# PRIVATE SANITARY SEWER EXTENSION

TO SERVE  
**WICHITA MID-CONTINENT AIRPORT**

PRIVATE PROJECT NO. 1910 PPS (607861)

**AS BUILT PLANS**  
 Contractor: Dondlinger  
 Inspector: Lyle Powers, Baughman Co.  
 pdf's by: KEK, 1/21/10

**CU102**

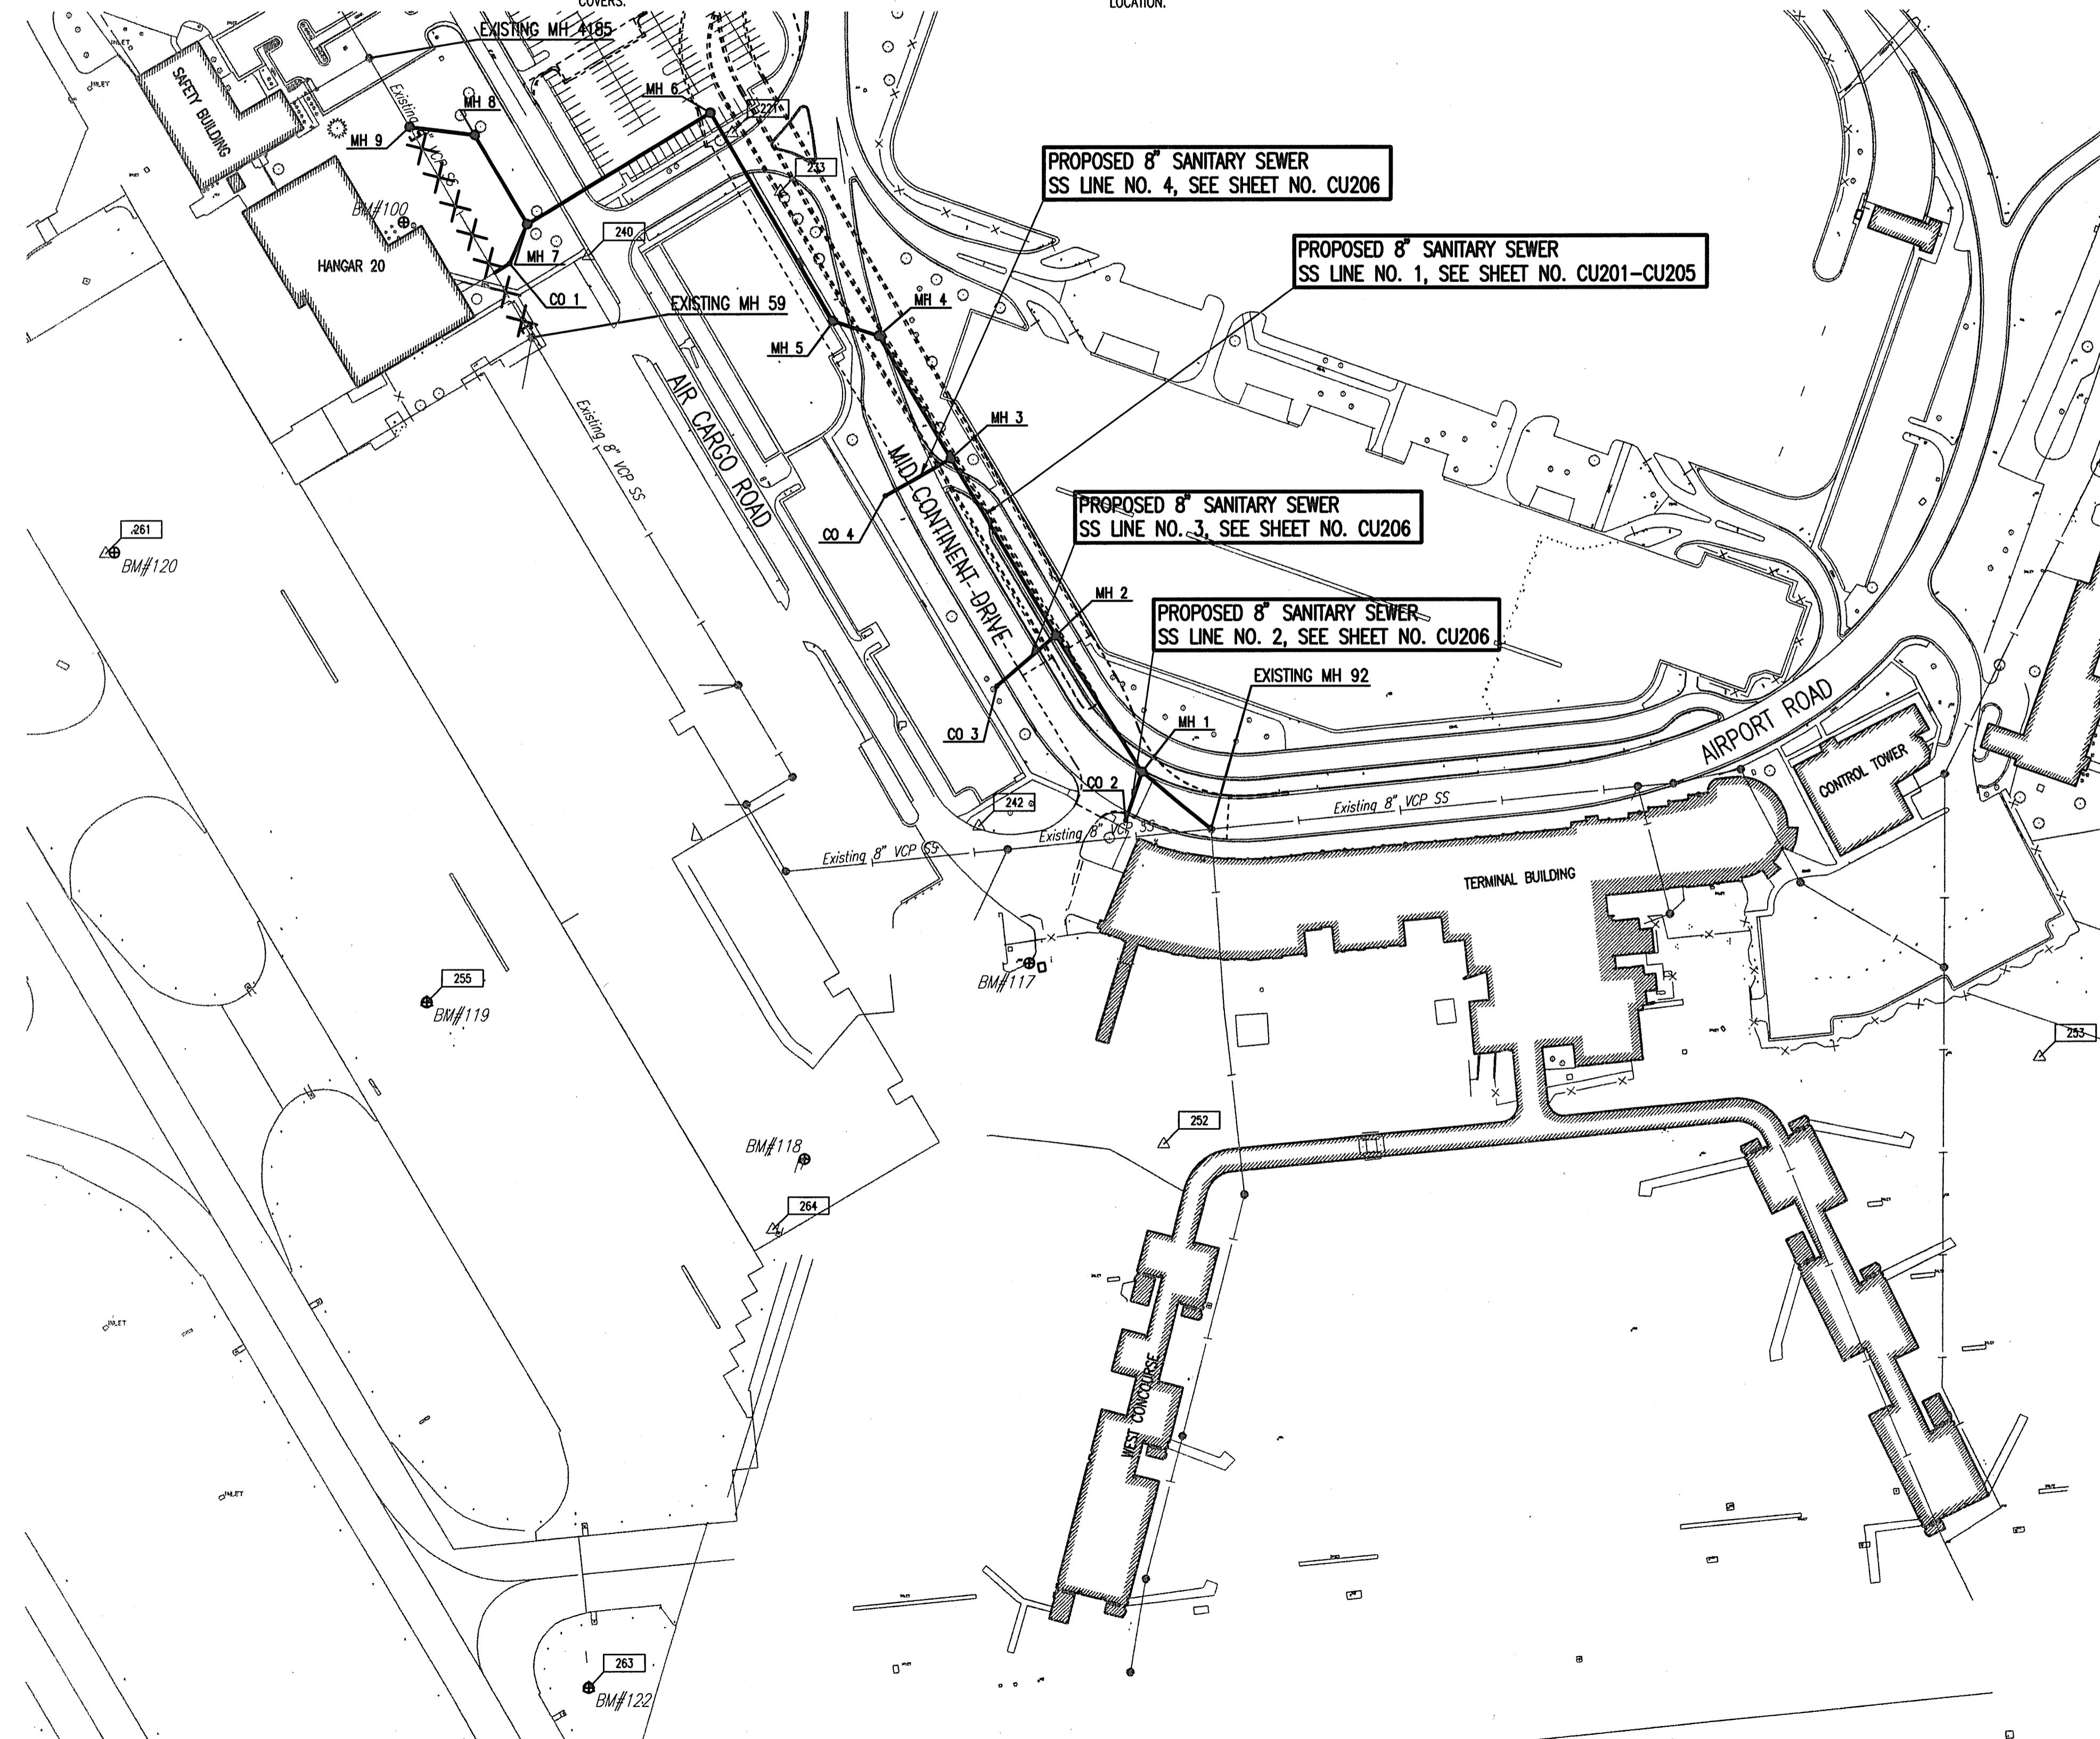
- ALL MANHOLE TOPS TO BE INSTALLED IN PAVED AREAS SHALL BE SET FLUSH WITH PROPOSED PAVEMENT ELEVATIONS. ADD #3 "Earth adjacent to manholes set in grassed areas shall be sloped away from manhole top at 10% to match grade."

**CU600A**

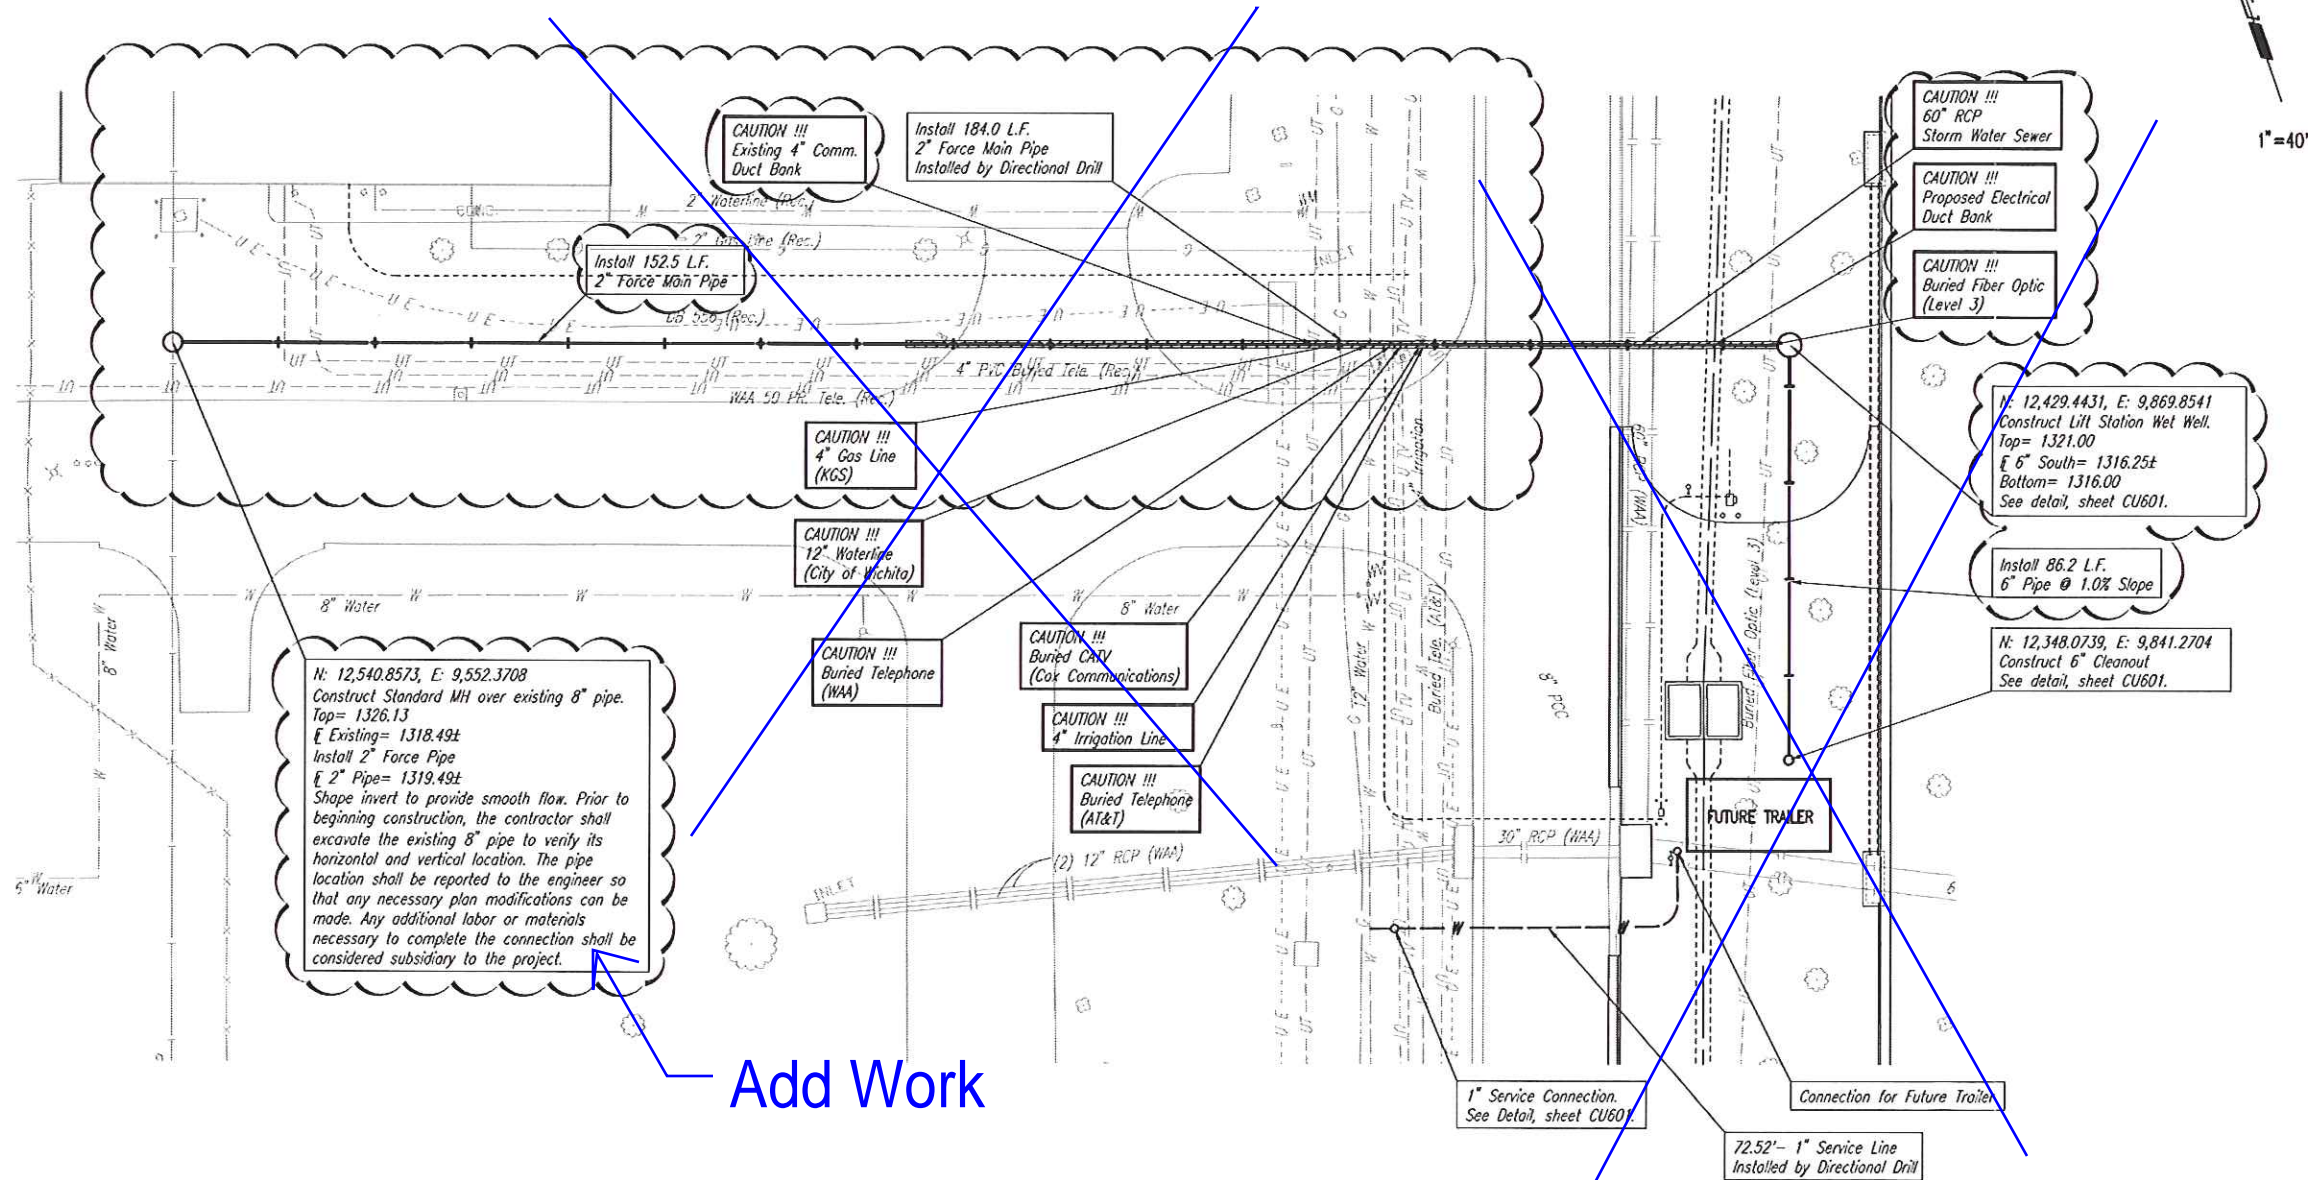
N: 12,540.8573, E: 9,552.3708  
Construct Standard MH over existing 8" pipe.  
Top= 1326.13  
Existing= 1318.49±  
Install 2" Force Pipe  
2" Pipe= 1319.49±  
Shape invert to provide smooth flow. Prior to beginning construction, the contractor shall excavate the existing 8" pipe to verify its horizontal and vertical location. The pipe location shall be reported to the engineer so that any necessary plan modifications can be made. Any additional labor or materials necessary to complete the connection shall be considered subsidiary to the project.

**CP200**

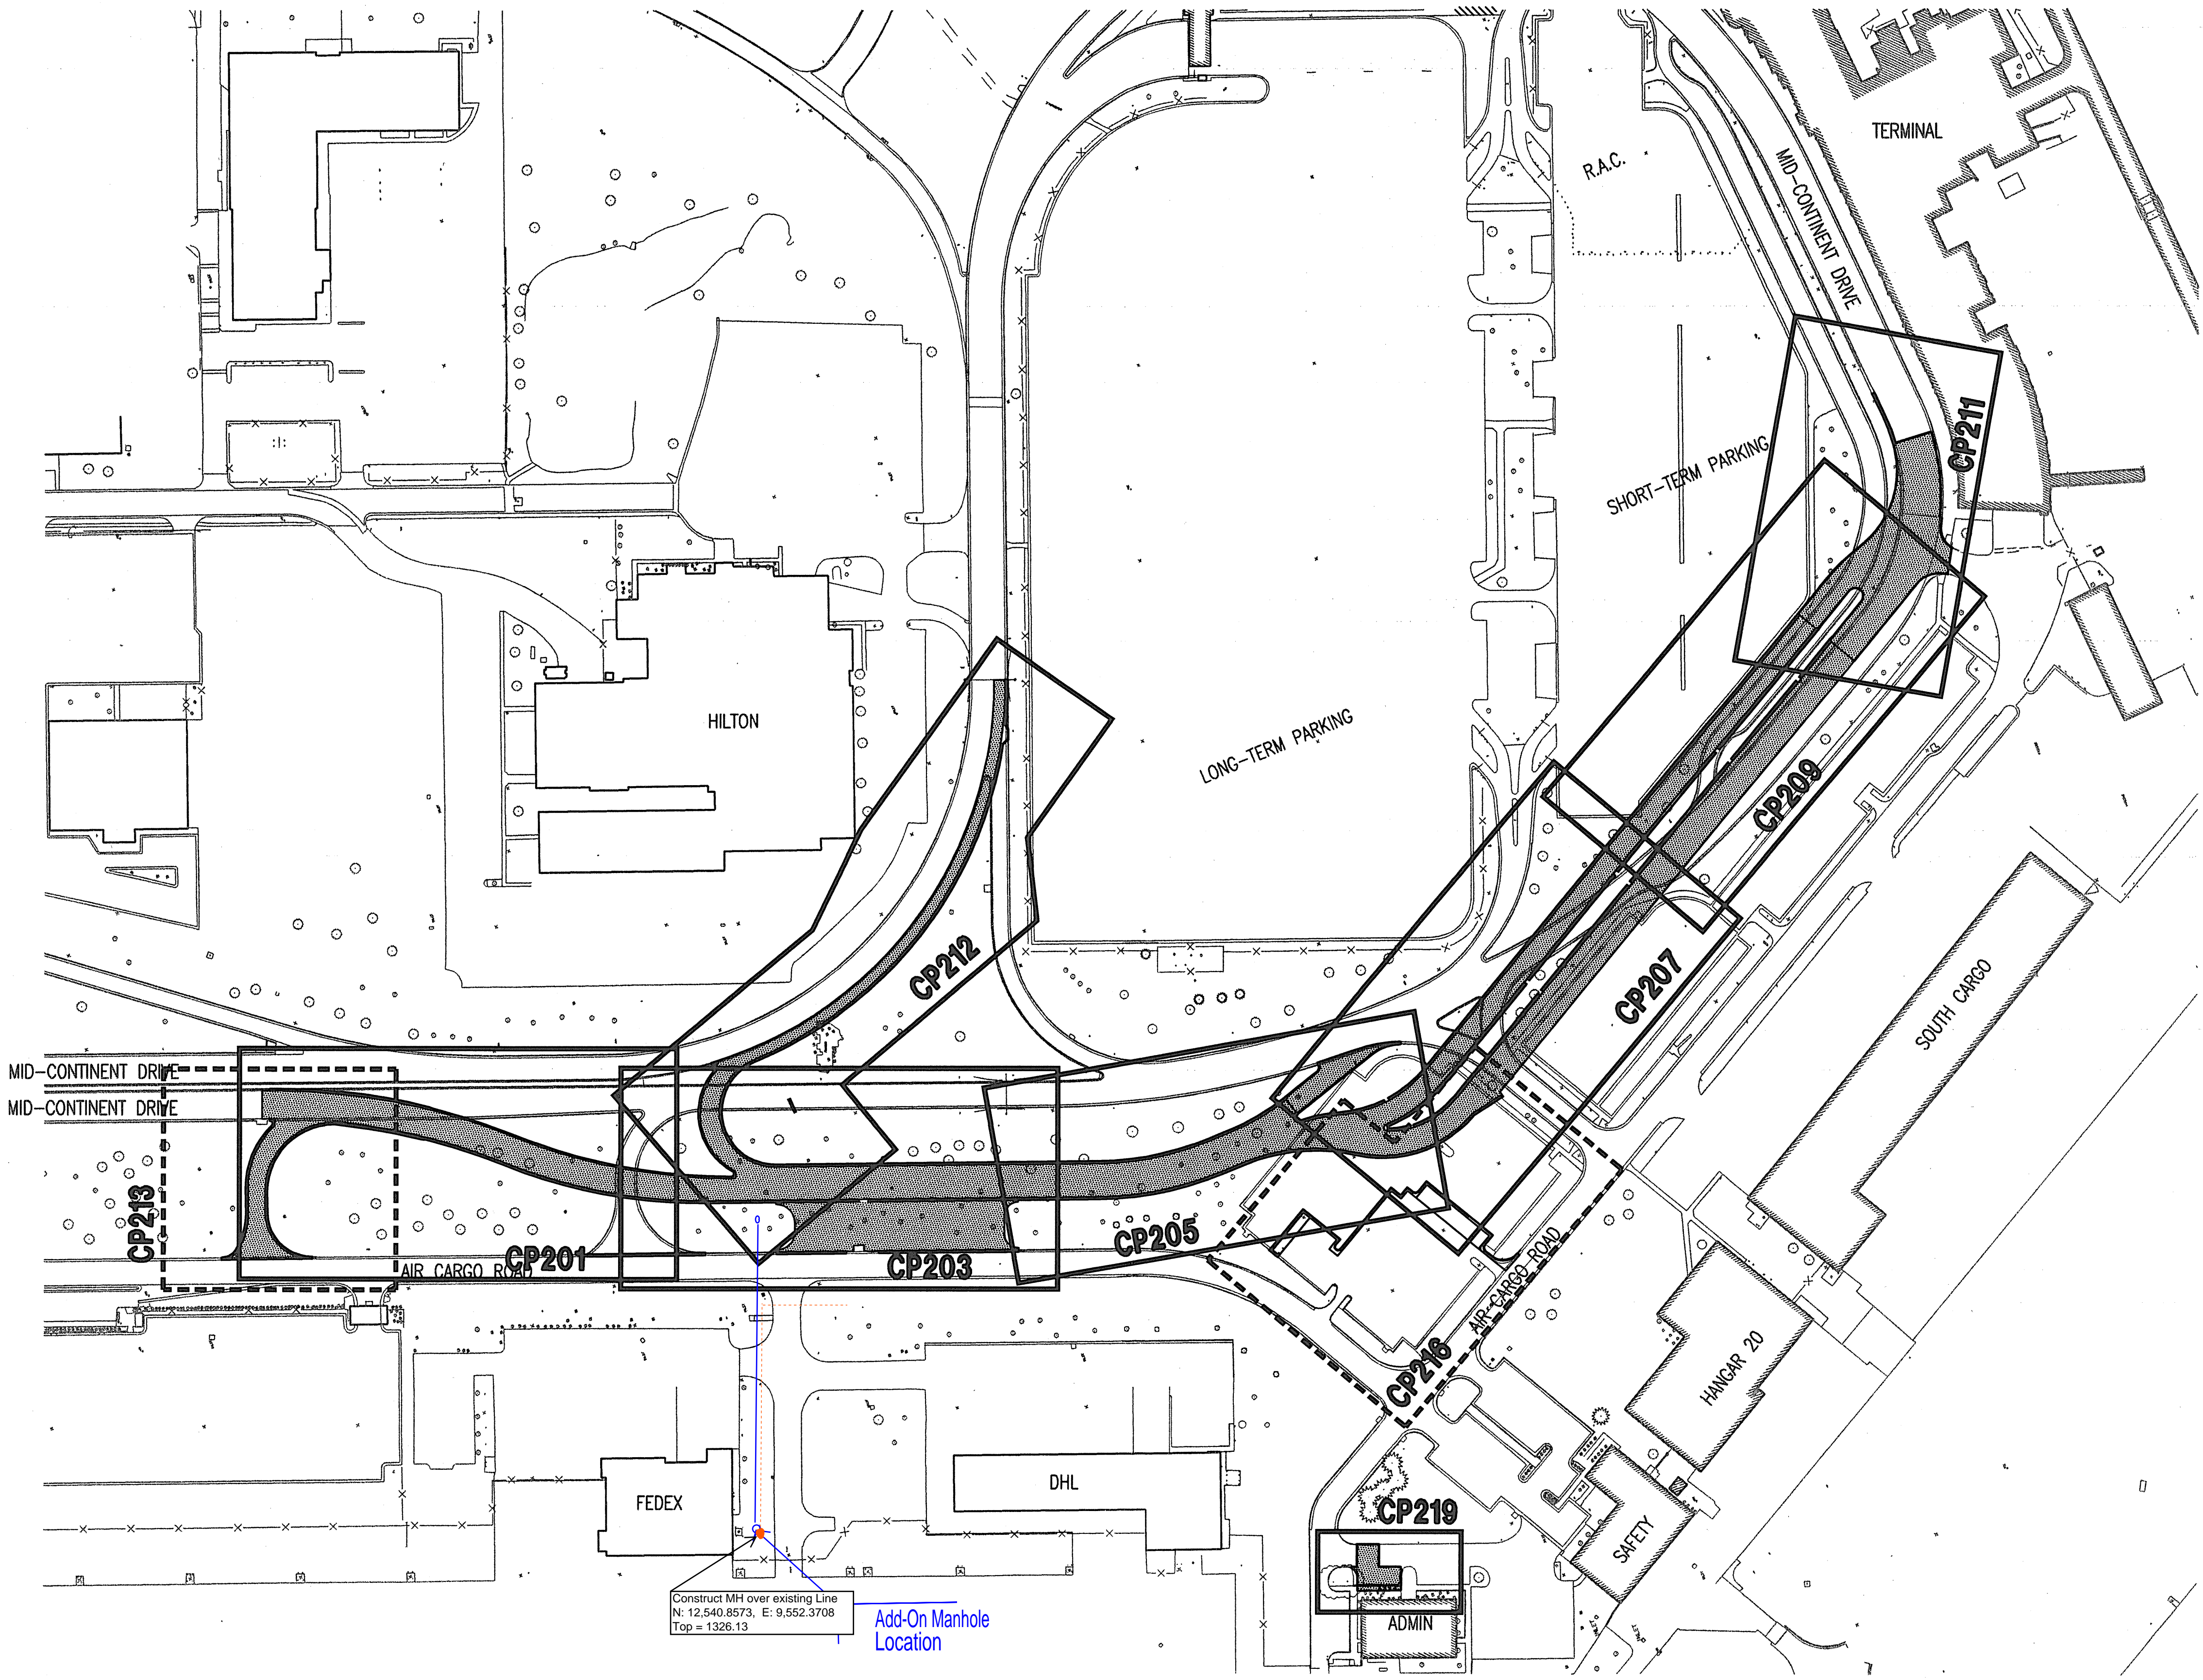
Construct MH over existing Line  
N: 12,540.8573, E: 9,552.3708  
Top = 1326.13  
Add-On Manhole Location
